BEACON PLANNING BOARD
Via Video-Conference
BEACON, NEW YORK 12508
Phone (845) 838-5002 Fax (845) 838-5026

Beacon Views - Conklin Street

Continue public hearing for SEQRA environmental review on applications for Subdivision and Site Plan Approval, "Beacon Views Townhouses" 40 units, Conklin Street, submitted by Beacon Views, LLC

RE: Beacon Views Site Plan and Conservation Subdivision
Conklin Street
Beacon, New York
Tax Parcel ID: 6055-03-331123

DRAWING: COVER SHEET

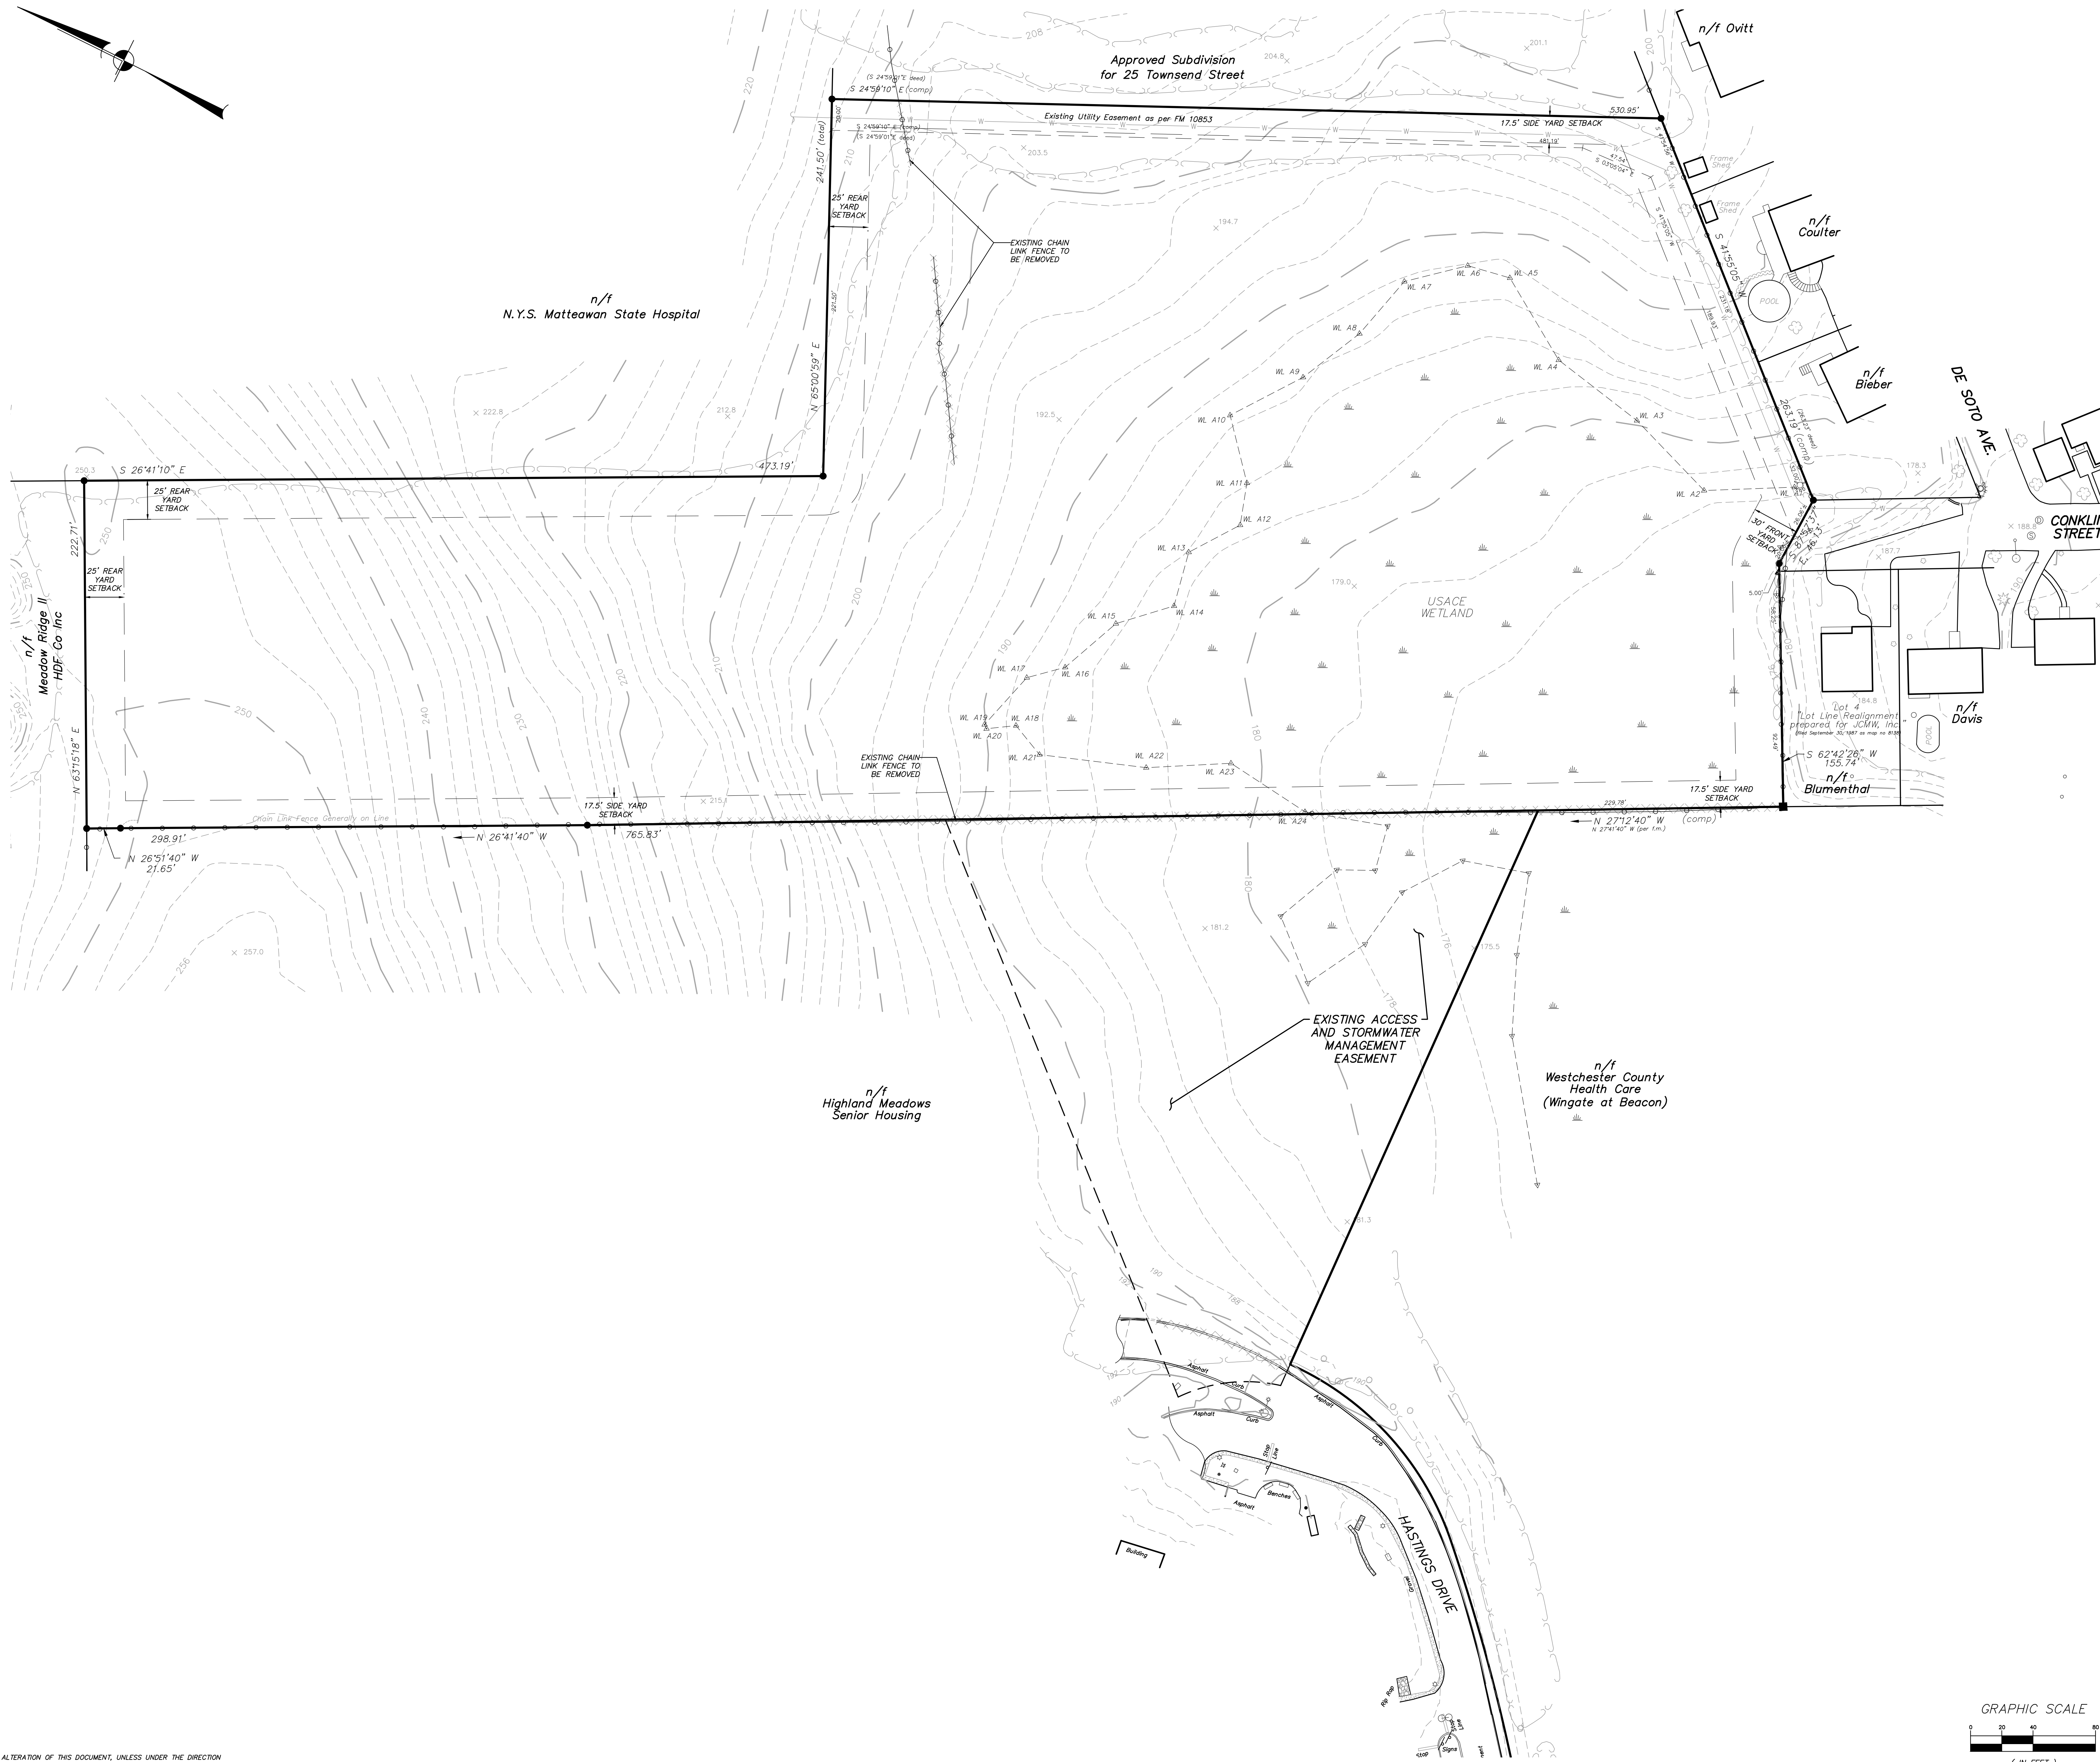
1. The Site Access Notes have been revised to describe the contingency for the alternative emergency access point at Conklin Street in the event that the 25 Townsend Street access was unavailable, and the proposed road through Highland Meadows property were to function as the primary access to the site.

2. The road shown in the existing easement on the Highland Meadows Senior Housing Project would be utilized as an emergency access only, in this case.
3. In the event there is a delay in the construction of the road in the approved 25 Townsend Street right of way, the applicant will retain ownership of the Highland Meadows Senior Housing Property, and utilize the proposed road thereon as the primary access to the site, until such time as the 25 Townsend Street road was constructed. In this event, the applicant will be responsible for the construction of an emergency access on sheet SP-4 would be constructed. When access becomes available through the Highland Meadows Subdivision, the road through the Highland Meadows Senior Housing Property easement would be gated and transferred to emergency access only, as stated above.

DRAWING: **UTILITIES PLAN**

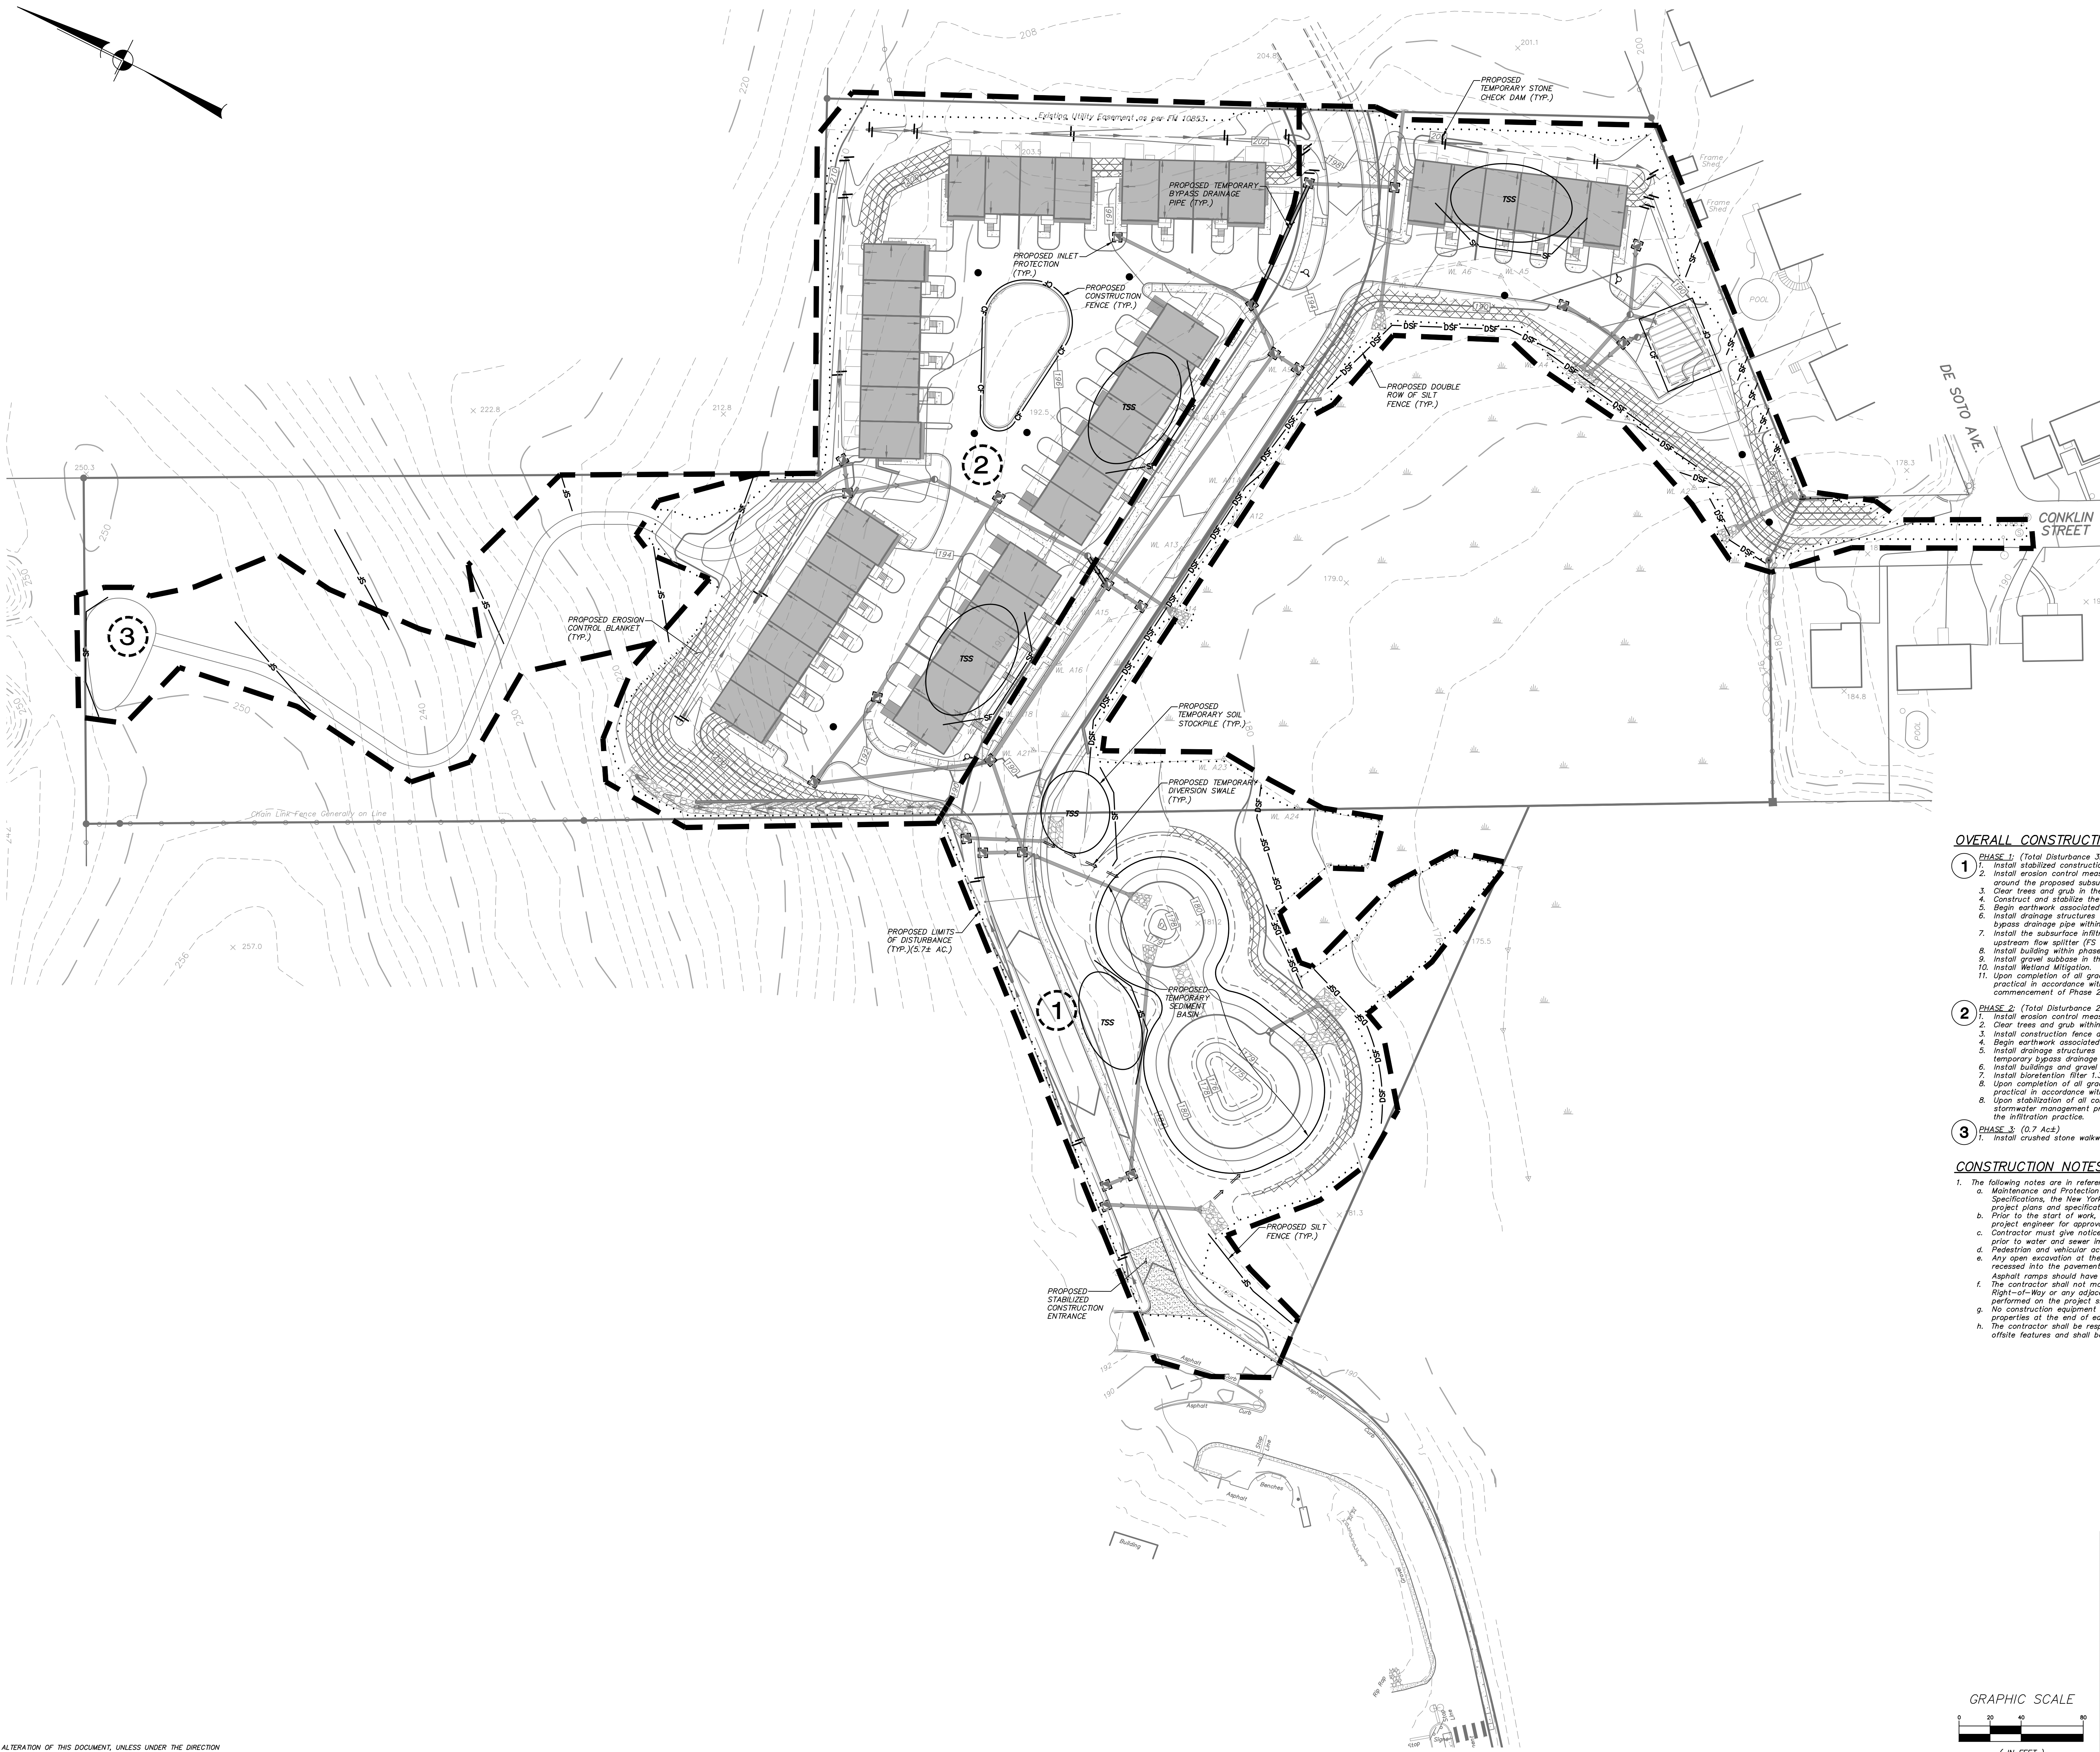
1. The lowest sewerable elevation for each proposed dwelling unit has been indicated on Drawing SP-2.2.
2. Proposed sewer manhole SMH 5B has been relocated as requested to reduce the lengths and bends for the proposed sewer laterals.
3. Cleanouts have been added to all proposed sewer laterals. A construction detail for the proposed cleanout has been added to Drawing D-4.
4. The proposed watermain has been indicated as 8" diameter Class 52 ductile iron pipe on the project plans.
